SAN RAFAEL TRANSIT CENTER COMMUNITY DESIGN ADVISORY GROUP

MEETING #4
WHAT WE HEARD REPORT

OCTOBER 2023

Relocated Depot Building Concept Update

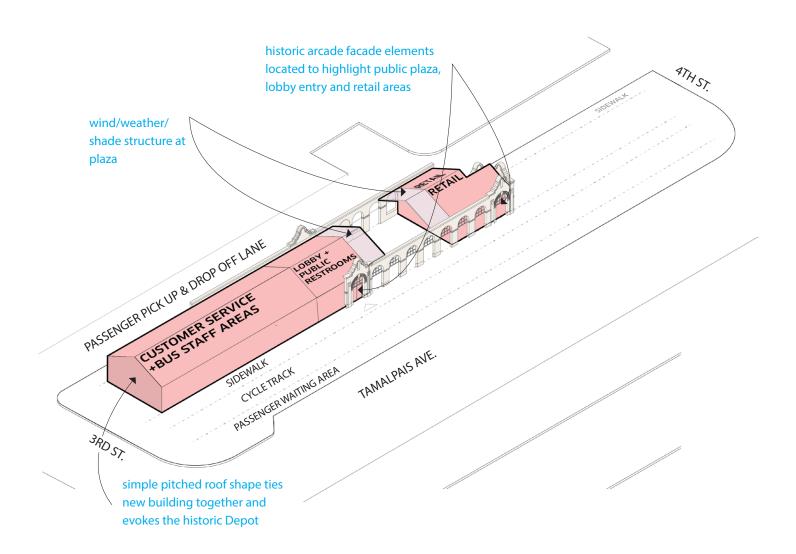
The CDAG made the following comments about the building concept, specifically related to the arcade and courtyard function:

- Is there opportunity for landscaping? Can we green this area up?
- Curious about comparison of proposed building to the original Depot.
- How does the open arcade get closed?
 Design Team: This will be detailed during the Final Design phase.
- Is it necessary that the arcade space be programmed?
 Design Team: Not necessarily, but it is an opportunity for seating and other uses.
- Consideration for covering the arcade courtyard with the original Depot roof line.
- Keep the back side of the arcade closed (close off the east side doors).

View from the Courtyard Looking East

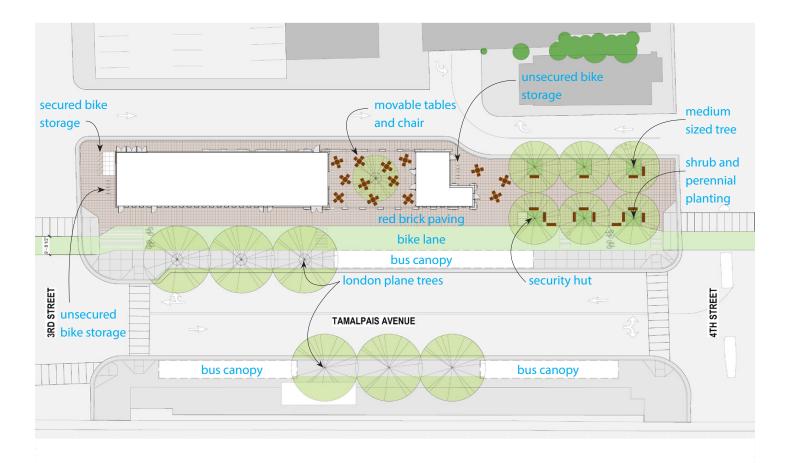
- Should the arcade courtyard be covered? Something like glass? Make the interior space usable in inclement weather.
- A large opening from Depot into the plaza is a great idea, but maybe the garage door is too industrial or not as functional. A French door might be better.
- Rise up doors not practical for when big storms come up.
- Does the arcade courtyard seating take away from the north plaza?
- The north frontage of retail there needs to be a cafe, and it needs to serve outdoor seating in the plaza.
